Author of the thesis: Bc. Joaquín Rodrigo Llanos Espinoza
Title of thesis: Mathematical Modelling of Solid-Liquid Flow in Open Channel
Master thesis opponent: Dr. Ing. Petr Nowak
 CTU, Faculty of civil engineering
 Department of hydraulic structures

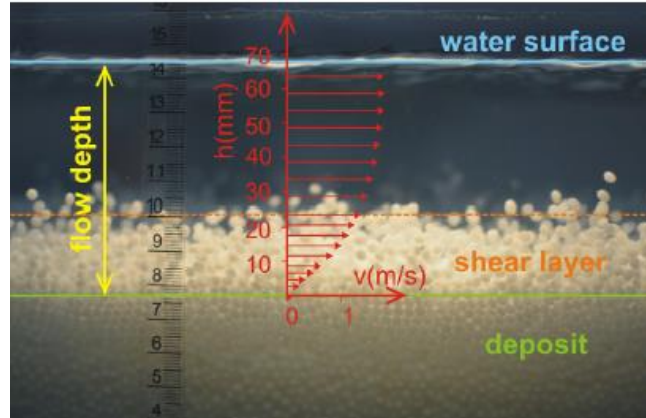
The accuracy of the interpretation is related to a very broadly defined task. I do not have practical experience in the field of "sediment transport", because I see applications in hydropower specialization only in sand traps on inlet objects or siltation of waterways. If I assume that the aim of the paper was to simulate a physical phenomenon that was investigated in the laboratory (see illustration photo), the conclusions of the paper are overstated.
